## PRODUCT CHANGE NOTICE

**EOL/PCN#23-030**

<b>Mini-Circuits PN:</b>	<b>Suggested Replacement Model:</b>	<b>Replacement Guide:</b>
NCS3-272+	NCS2-33+	Please see pages 2 through 5

### REPLACEMENT PART REFERENCE GUIDE, NCS3-272+

#### MECHANICAL DIMENSIONS & PCB LAND PATTERN

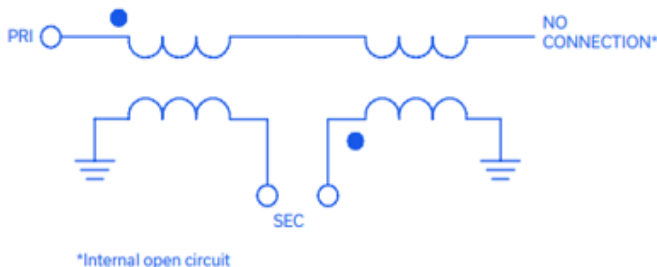
Change to FORM (Appearance), minor change to FIT (height dimension) not affecting device footprint and FUNCTION (Performance) specification changed to reflect performance

ORIGINAL PART: NCS3-272+	SUGGESTED REPLACEMENT PART: NCS2-33+																																																
<p>GE0805C-9</p> <table border="1" style="width: 100%; border-collapse: collapse; margin-top: 10px;"> <thead> <tr> <th>CASE #</th> <th>A</th> <th>B</th> <th>C</th> <th>D</th> <th>E</th> <th>F</th> <th>G</th> <th>H</th> <th>J</th> <th>K</th> <th>WT.GRAM</th> </tr> </thead> <tbody> <tr> <td>GE0805C-9</td> <td>.079 (2.00)</td> <td>.049 (1.25)</td> <td>.037 (0.95)</td> <td>.014 (0.35)</td> <td>.012 (0.30)</td> <td>.012 (0.30)</td> <td>.026 (0.65)</td> <td>.014 (0.35)</td> <td>.039 (1.00)</td> <td>.110 (2.80)</td> <td>.008</td> </tr> </tbody> </table> <p><small>Dimensions are in inches (mm). Tolerances: 2PL ±.01; 3 PL ±.005</small></p>	CASE #	A	B	C	D	E	F	G	H	J	K	WT.GRAM	GE0805C-9	.079 (2.00)	.049 (1.25)	.037 (0.95)	.014 (0.35)	.012 (0.30)	.012 (0.30)	.026 (0.65)	.014 (0.35)	.039 (1.00)	.110 (2.80)	.008	<p>GE0805C-1</p> <table border="1" style="width: 100%; border-collapse: collapse; margin-top: 10px;"> <thead> <tr> <th>CASE #</th> <th>A</th> <th>B</th> <th>C</th> <th>D</th> <th>E</th> <th>F</th> <th>G</th> <th>H</th> <th>J</th> <th>K</th> <th>WT.GRAM</th> </tr> </thead> <tbody> <tr> <td>GE0805C-1</td> <td>.079 (2.00)</td> <td>.049 (1.25)</td> <td>.033 (0.84)</td> <td>.014 (0.35)</td> <td>.012 (0.30)</td> <td>.012 (0.30)</td> <td>.026 (0.65)</td> <td>.014 (0.35)</td> <td>.039 (1.00)</td> <td>.110 (2.80)</td> <td>.008</td> </tr> </tbody> </table> <p><small>Dimensions are in inches (mm). Tolerances: 2PL ±.01; 3 PL ±.005</small></p>	CASE #	A	B	C	D	E	F	G	H	J	K	WT.GRAM	GE0805C-1	.079 (2.00)	.049 (1.25)	.033 (0.84)	.014 (0.35)	.012 (0.30)	.012 (0.30)	.026 (0.65)	.014 (0.35)	.039 (1.00)	.110 (2.80)	.008

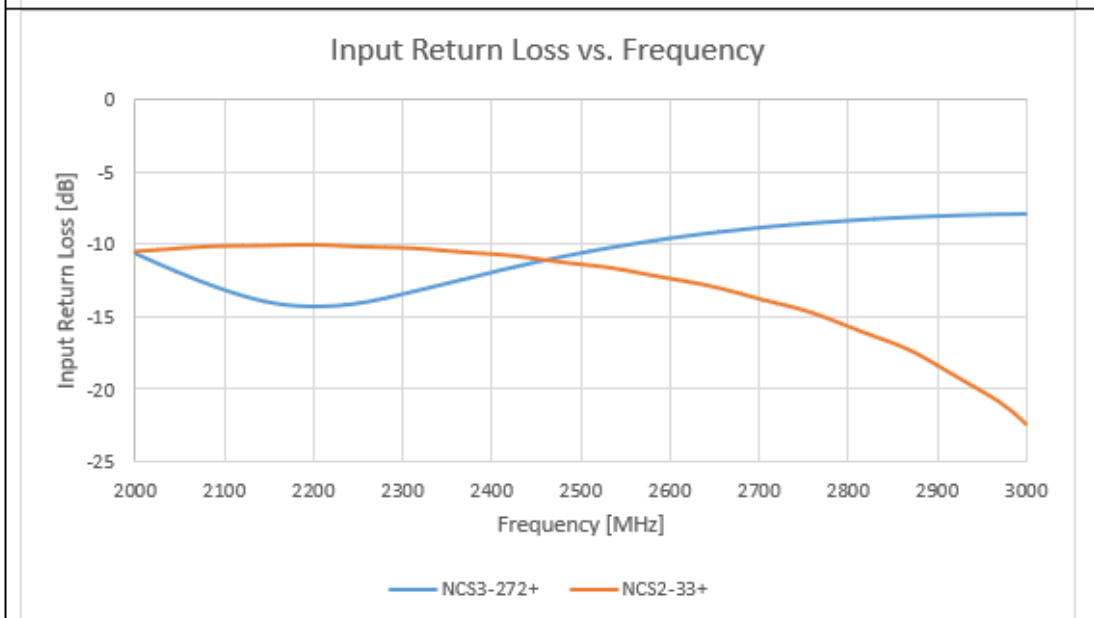
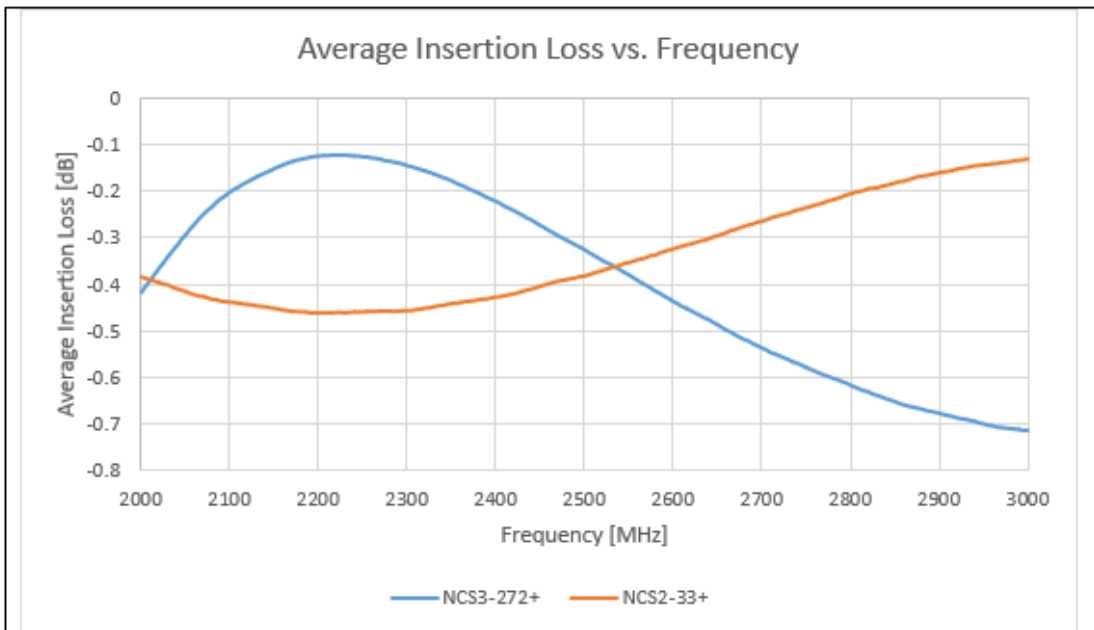
The suggested replacement part is Form and Fit compatible.  
Following is a summary of electrical changes/improvements:

Parameter	Original Part (NCS3-272+)	Suggested Replacement Part (NCS2-33+)
Impedance Ratio (Secondary/Primary)	3	2
Frequency Range	2250 – 2725 MHz	1500 – 3100 MHz
Average Insertion Loss	1dB max	1dB max
Amplitude Unbalance	0.4db typ.	0.6dB typ.
Phase Unbalance	3 degrees typ.	5 degrees typ.
Operating Temperature	-40C to +85C	-40C to +85C
Storage Temperature	-50C to 100C	-50C to 100C
RF Power	3W max	3W max
